**UNITED STATES  
NUCLEAR REGULATORY COMMISSION  
ADVISORY COMMITTEE ON REACTOR SAFEGUARDS  
WASHINGTON, DC 20555 - 0001**

October 22, 2009

**SUBJECT:** CLOSURE OF STEAM GENERATOR ACTION PLAN ITEMS 3.1k, 3.4, 3.5, 3.10, 3.11, and 3.12

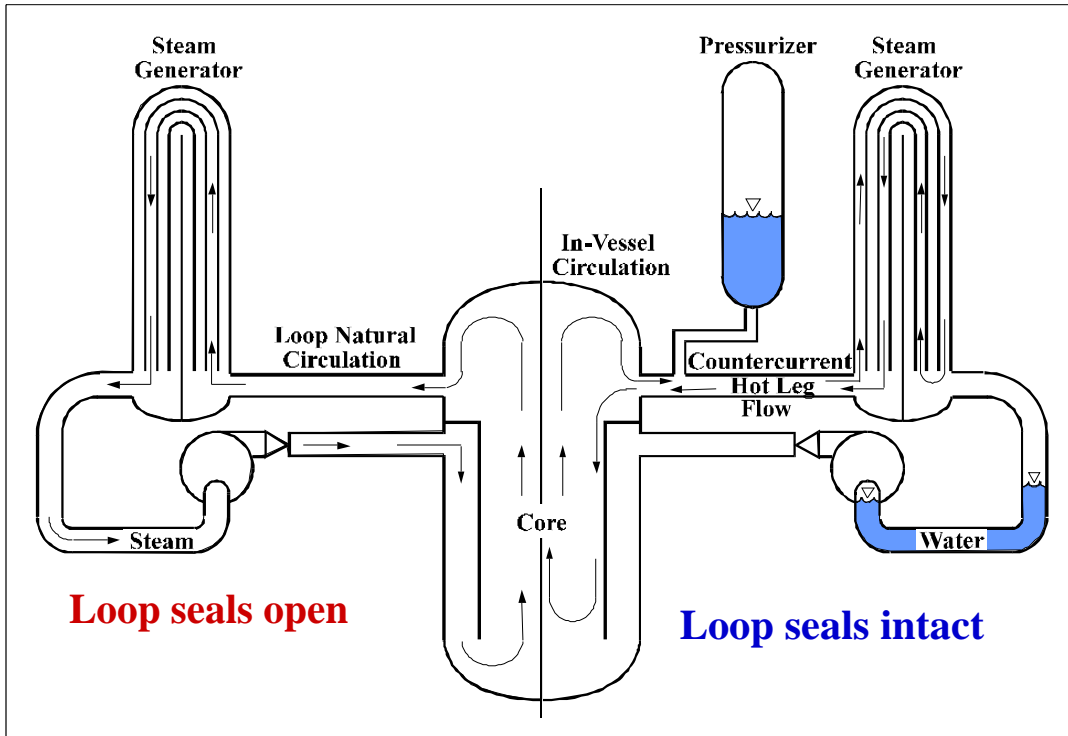
The threat to tube integrity during the progression of a core meltdown accident arises from the natural convection of hot steam and hydrogen from the core region to the steam generators. Two limiting patterns for such natural convection are depicted schematically in Figure 1. On the left of this figure, the loop seals are open and full convective flow through the tubes can occur. On the right, loop seals are shown to be intact. A very complicated countercurrent flow of gas through the hot leg and the steam generator develops in this case. The concern for both possible natural convection patterns is that heat loads placed on the tubes by convection currents could be sufficient that tubes will fail by creep rupture.

Convection currents that develop when the loop seals are open impose the highest heat loads on the steam generator tubes and under these conditions failure is likely. Opening of the loop seals is a complicated issue that depends very much on specific design features of the reactor coolant system. We have not reviewed capability of existing accident analysis computer codes to predict the clearing of loop seals during accident progression.

For many plants, it is thought more likely that loop seals will remain intact for much of the core damage progression. Heat loads imparted to the steam generator tubes in the case of countercurrent natural circulation are mitigated by the mixing in the lower plenum of the steam generator of hot gases coming from the core region with cooler gases in the return flow.
